LAND AT CROSSINGS ROAD, CHAPEL-EN-LE-FRITH HPK/2025/0477

Tetra Tech RPS have been asked by the applicants to provide a response to the archaeological comments provided by your consultees, DCC Archaeology.

IMAGES 1 & 2: LiDAR images of irregular earthworks within application site, illustrating the irregular plan-form, variable internal nature, and absence of any potential breaks in the surrounding earthwork 'enclosure'

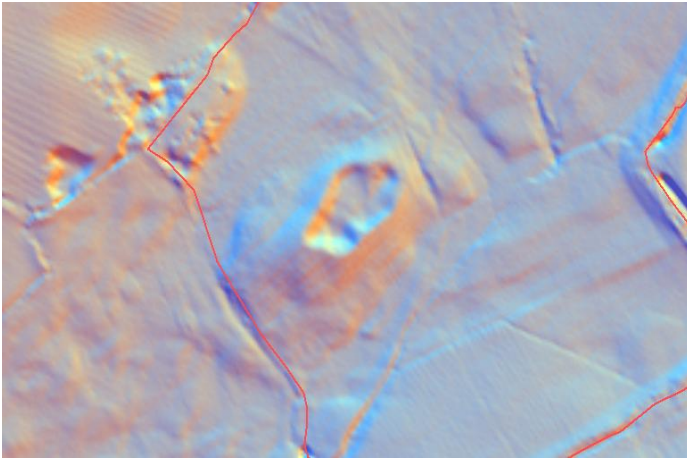
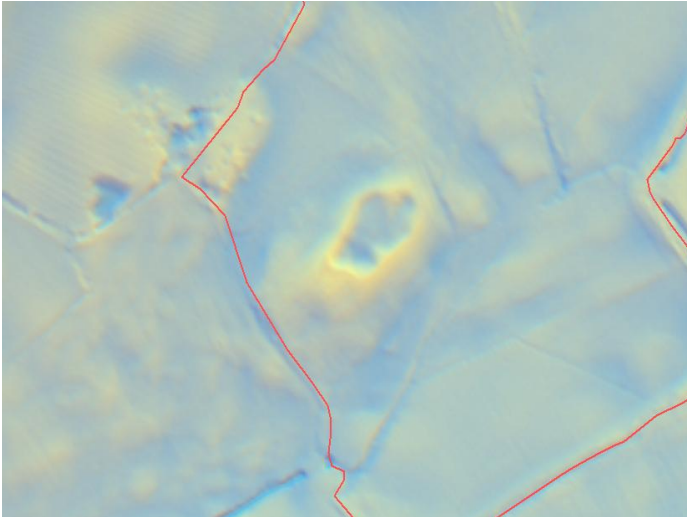
The comments identify the most visible potential archaeological interest in the site as an irregular sub-oval earthwork enclosure towards the southern boundary of the application site; DCC's comments recognise the interpretation of this feature provided in our desk-based assessment as evidence for historic sand and gravel extraction, and acknowledges that this is 'entirely plausible' interpretation although the possibility of other alternative interpretations including medieval stock and drovers' enclosures, or even earlier - prehistoric or Romano-British - enclosures are noted.

The primary concern appears to be that the 'enclosure' might be earlier in date and not related to gravel / sand extraction, and the county's response advises that further archaeological field evaluation should be undertaken to clarify the interpretation of the earthworks.

Following our receipt of the consultee comments from the applicants, we have re-examined the relevant information used in our desk-based archaeological assessment – submitted with the application. The LiDAR shows a clear truncation of the agricultural trends visible within the field – suggesting that the feature post-dates these; we note that there are no obvious breaks or 'openings' in the earthworks which might be expected of an functional enclosure, and the feature has a very variable profile, depth and planform. These aspects of the earthworks are clearly illustrated in the set of LiDAR images [1 & 2] and the site photo [3] which accompany this letter.
